SERVICE No. 1042 BULLETIN

SUBJECT: Inspection of the Heated Deice Panel Installation

PA-34-220T Seneca V 3449002 through 3449152

Figure 1

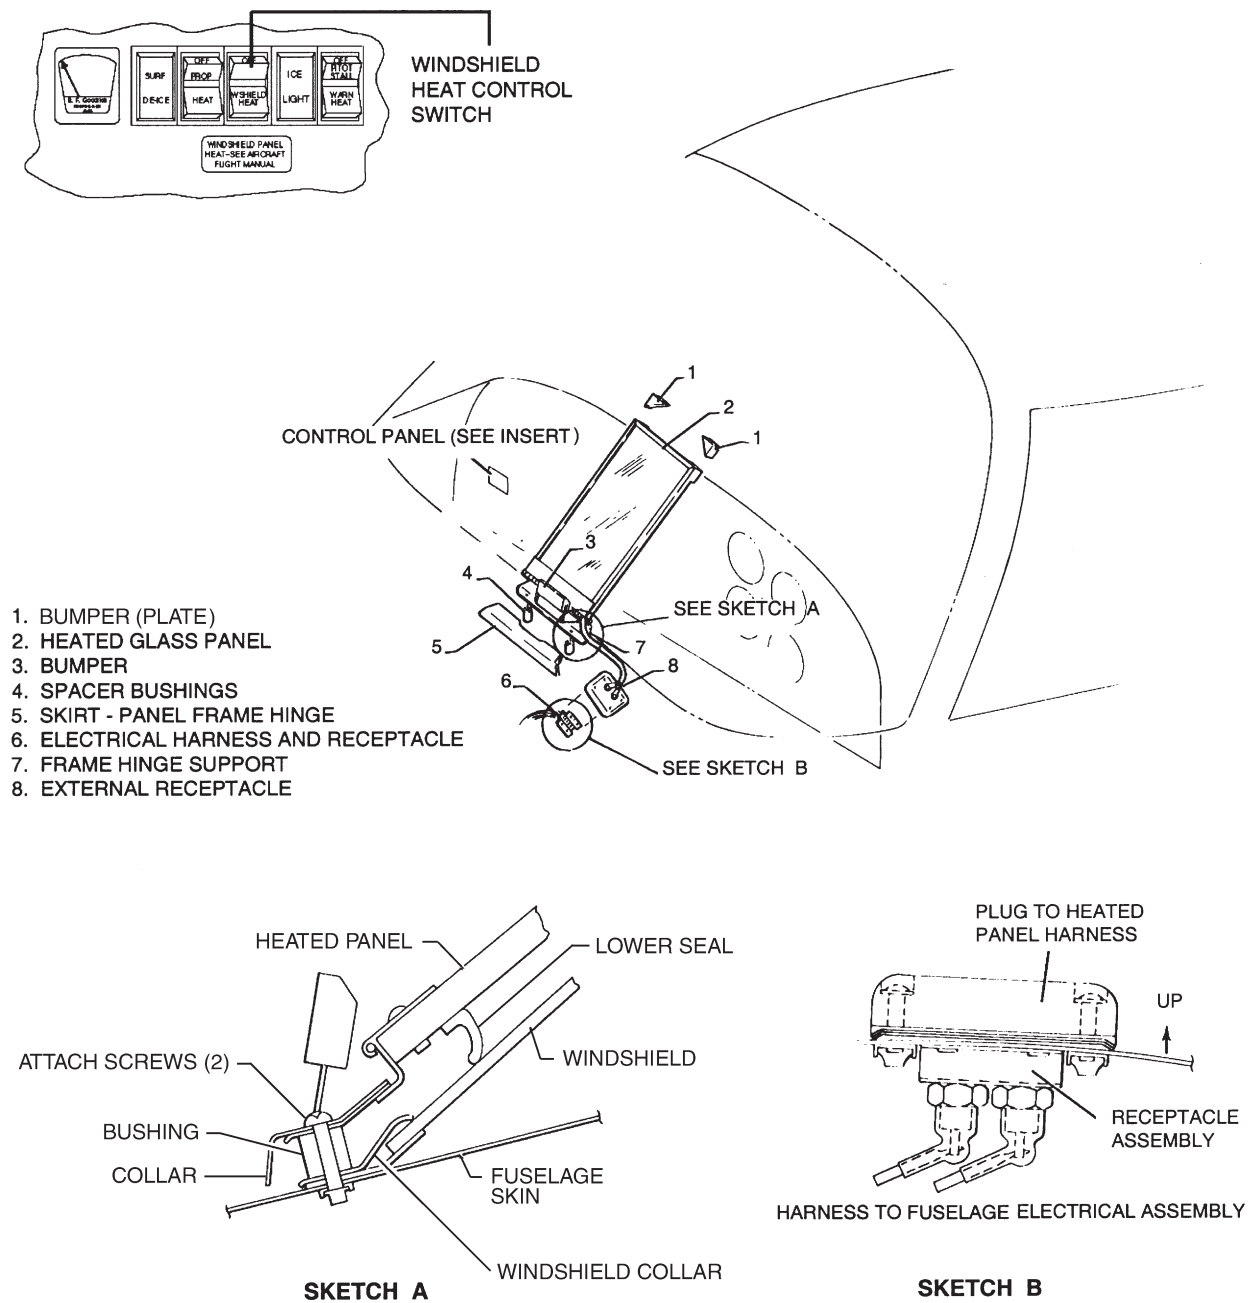
REFER TO FIGURE 1.

1. Inspect the Heated Deice Panel Installation to verify that the deice panel seals and bumpers are making full contact with the windshield, and that there are no gaps evident between the panel and the windshield. If any of these conditions are not satisfactory, proceed to Instruction 2.
2. Select Windshield Heat Control Switch to OFF and disengage the WSHLD HEAT circuit breaker. Remove electrical plug from receptacle assembly, if necessary.

3. Check that the seals are in good condition and fully bonded to the deice panel and that the lower and inboard seals are bonded together at the mitered corner. Seals that are in good condition but not fully bonded to the deice panel or not fully bonded together at the mitered corner may be rebonded using black RTV133, or equivalent, sealant.
4. If, after the seals are verified in good condition and properly bonded, there is still inadequate contact of the deice panel seals and bumpers with the windshield, continue with Instruction 5.

5. Adjust the deice panel so that the lower seal makes full contact with the windshield as follows:
 - (a) Remove the two MS35206-328 screws from the windshield collar and elongate the attachment holes in the deice panel to allow for more adjustment.

OR
 - (b) Trim the existing bushings as necessary and prime. After trimming the bushings, it will be necessary to file the collar on the deice panel to maintain 0.03 minimum clearance from the windshield collar.

OR
 - (c) Increase the height of the bushings by adding 0.063 aluminum washers (NAS1149DO363H).
 - (d) Install the deice panel to the windshield collar.
6. After the lower seal has been adjusted to make full contact with the windshield, insure the inboard seal makes full contact with the windshield by adjusting the upper corner bumpers as follows:

The inboard seal should extend below the bumpers 0.03 to 0.06 to allow for sufficient compression of the seal against the windshield in flight.

- (a) If additional height is needed for the bumpers, replace the existing bumpers with new bumpers (Piper Part Number 31637-03, length 11/16").
 - (b) If it is determined that the bumpers need to be trimmed, carefully trim as required to match the mating surface of the windshield.
7. Upon completion of adjustments:
 - (a) Be sure that the two screws that secure the deice panel to the windshield collar are sufficiently tightened.
 - (b)
